2040 MTP – Final Plan

Compilation of Public Comments

This document compiles all the comments that have been received from the public during the public input process for final 2040 Metropolitan Transportation Plan (MTP) report. All comments received by email and letters up to May 3, 2013 have been included.

Appendix 7

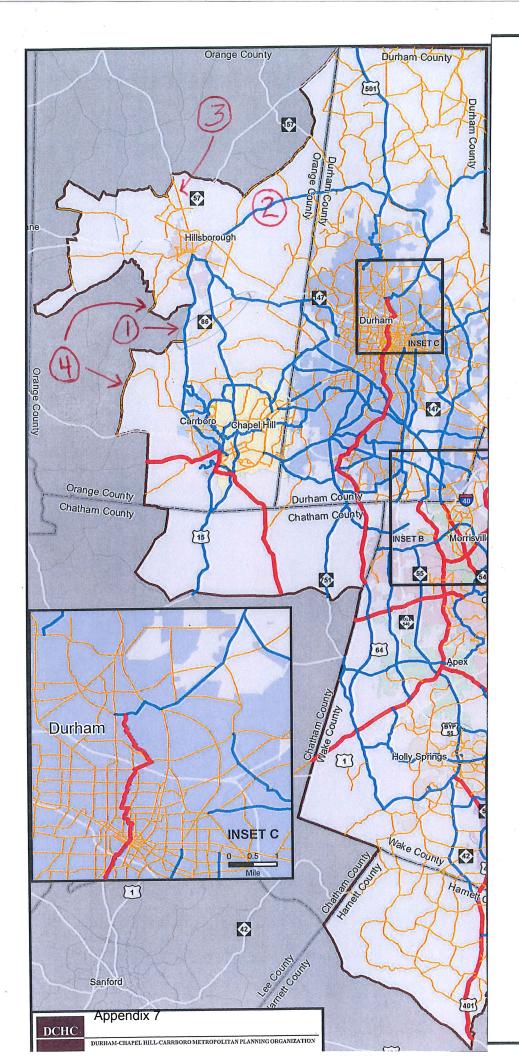
- 1. Old NC 86 segment between New Hope Church and Davis is identified as a Regional Bicycle Facility. Consistent with the County's Comprehensive Transportation Plan (March 2013), we are requesting that this designation be removed. New NC 86 provides the preferred alternate connection to Hillsborough from points south (If needed, the section of New Hope Church Road, connecting Old NC 86 to New NC 86 and beyond to Old NC 10, could be identified as a Regional Bicycle Facility rather than a Local Bicycle Facility).

- 2. St. Mary's Road segment between US 70 Bypass and Durham County line is identified as a Regional Bicycle Facility. Consistent with the County's existing bicycle route system (2010 NCDOT bicycling brochure), we are requesting that this designation be removed. The preferred alternate to Hillsborough from the Durham County line is via Guess Rd., New Sharon Church Rd., Walker Rd., Miller Rd., to Saint Mary's Rd.

- 3. NC 86 North segment between the intersections with Coleman Loop Road is identified as a Local Bicycle Facility. Consistent with the County's Comprehensive Transportation Plan (March 2013), we are requesting that this designation be removed and Coleman Loop Road be used as the preferred alternate.

- 4. <u>Orange Grove Road and Dodsons Crossroads Road</u> segments within MPO boundaries could be shown as Regional Bicycle Facilities rather than Local and may provide more of a regional connection south to Chatham County. The Orange County Comprehensive Transportation Plan includes the connections that complete the route.
